SUBJECT: Beaver Valley Power Station - Unit 2  
Docket No. 50-412  
Environmental Report - Accident Evaluation

NRC Letter: December 2, 1983

## Question E450.1

## Question E450.2

FIGURE 7.1-5  
POINT ESTIMATE RISK CURVE FOR  
THYROID CANCER FATALITIES  
BEAVER VALLEY POWER STATION-UNIT 2  
ENVIRONMENTAL REPORT  
OPERATING LICENSE STAGE

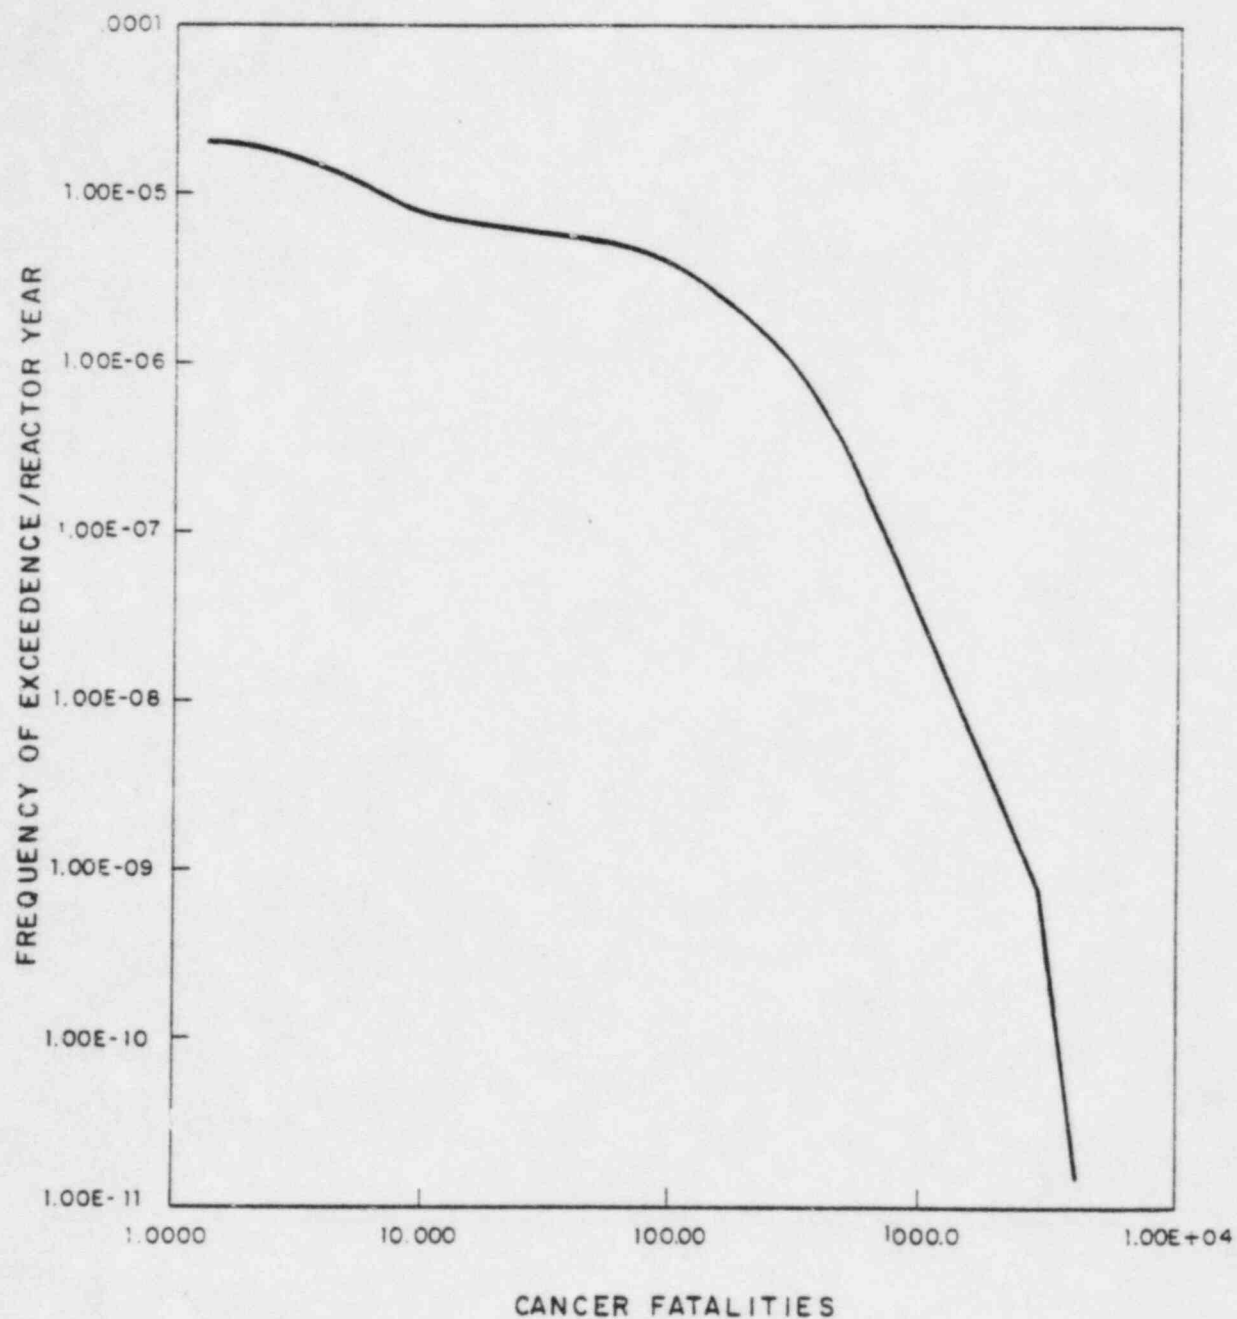
- a. Your use of the population data for the year 1980, instead of the data for the plant mid-life year, is consistent with the staff's practice. Please provide basis for your selection of this population data; and
- b. Information regarding the following items are absent in ER-OL:
  - i. Risk estimates to an individual of early fatality as a function of distance or as isopleths,
  - ii. Probability distribution and risk estimates of thyroid cancer fatalities,
  - iii. Estimated person-rem and cancer fatalities (excluding thyroid, and thyroid only) CCDFs and risks within the 50-mi region,
  - iv. Estimated distributions of number of persons exposed above 25 rems to whole-body, 300 rems to thyroid, and 200 rems to total bone marrow from early exposure, and
  - v. Estimated economic cost of damage to the plant.

- b. (ii) The risk curve for thyroid cancer is provided on Figure 7.1-5, Amendment 5.
- b. (iii) Generation of risk curves for the population within 50 miles of BVPS-2 requires an additional set of CRAC runs. The additional information gained by performing these analyses does not warrant the additional effort required.
